BEFORE THE IDAHO PUBLIC UTILITIES COMMISSION

IN THE MATTER OF IDAHO POWER)	
COMPANY'S 2015 INTEGRATED RESOURCE)	CASE NO. IPC-E-15-19
PLAN.)	
)	COMMENTS OF THE
)	COMMISSION STAFF
)	
)

The Staff of the Idaho Public Utilities Commission comments as follows on Idaho Power Company's Application.

Figure 9.1 Portfolio stochastic analysis

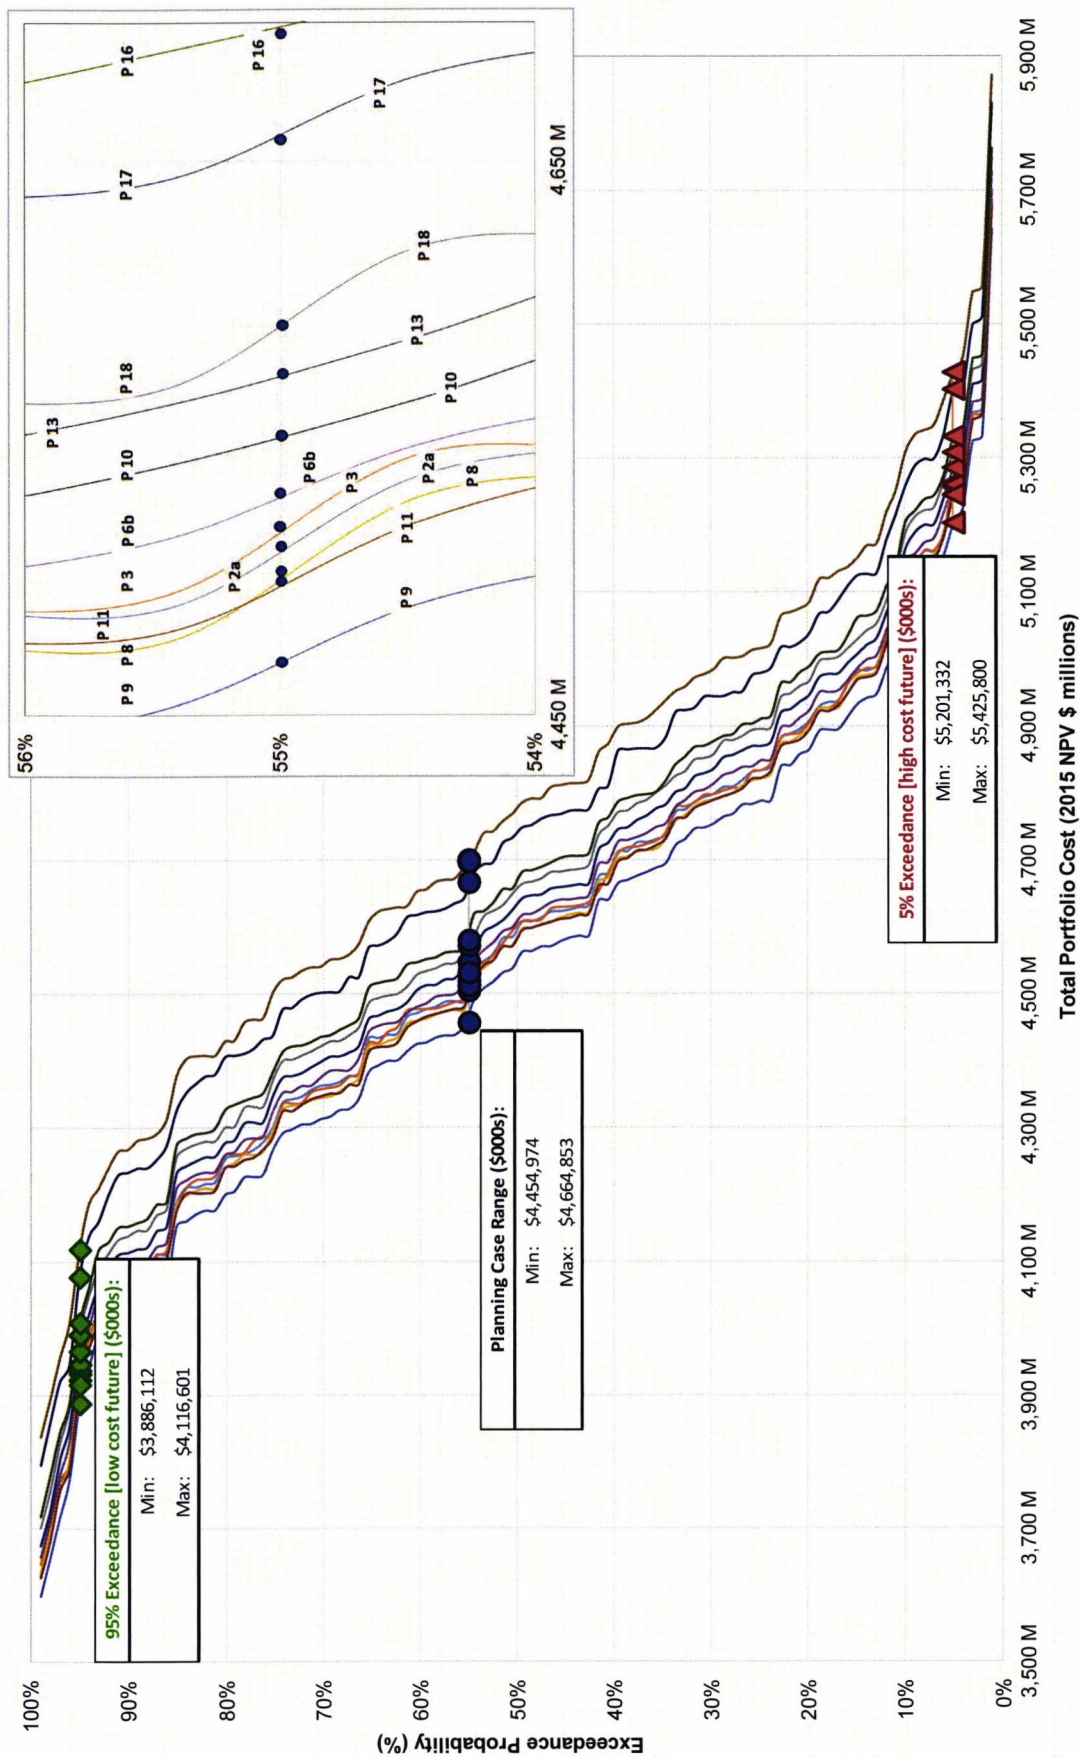
The Company notes the unequivocal findings of its stochastic risk analysis (*see* Staff Attachment C):

. . . [T]he lack of significant cross of lines [in the risk analysis] is a testament to the resource diversity of Idaho Power's existing portfolio and the portfolios of new resources considered in the IRP; under no set of stochastic futures is a portfolio a clear and runaway cost winner, only to be countered by a different set of futures for which it is just as clearly a losing portfolio susceptible to significantly higher costs than other portfolios.¹¹

Staff agrees with this assessment because it affirms the Company's robust risk analysis. However, Staff believes the assessment undermines the Company's selection of Portfolio 6(b) as the preferred portfolio because the risk analysis finds that Portfolio 6(b) is the sixth most risky portfolio out of the eleven studied.
